City of Albuquerque

May 10, 1999

Re: Los Prados del Norte - Unit 1, File No. D16/D8, engineer's stamp
dated April 7, 1999.

**Re: Los Prados Del Norte Grading and Drainage Plan (D-16/D8), Engineer's stamp 4-7-99
Preliminary Plat and Rough Grading Permit Approval**

PROJECT Los Prados Del Norte
SUBJECT Swamp Inlet Calcs
BY DLH DATE 3-5-99
CHECKED _____ DATE 4-7-99 REV
SHEET 1 OF 2

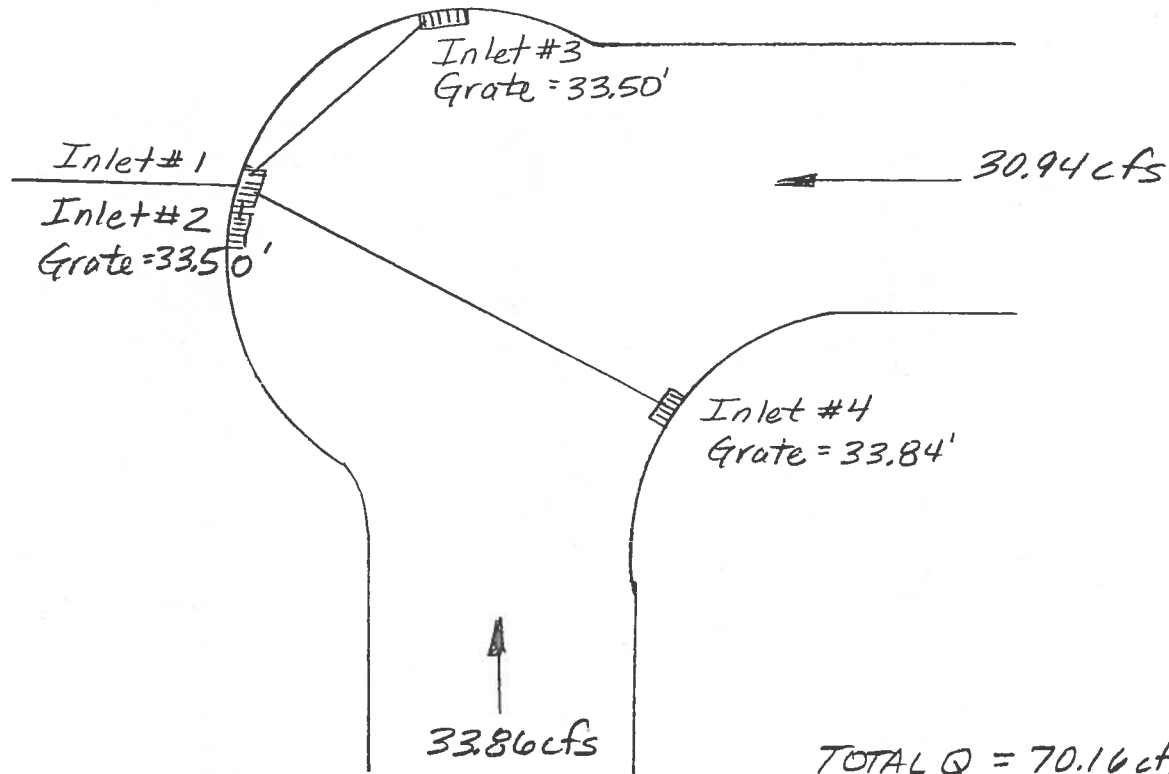
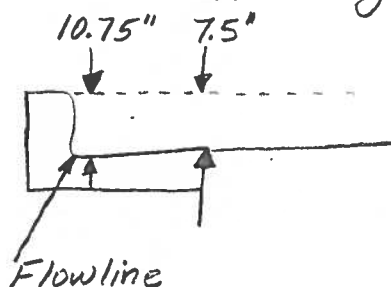
4. Inlets have been identified on the revised grading and drainage plan and in the supplemental information. GI-
5. I understand that Parsons-Brinkerhoff has made a submittal to the State Engineers Office. OK
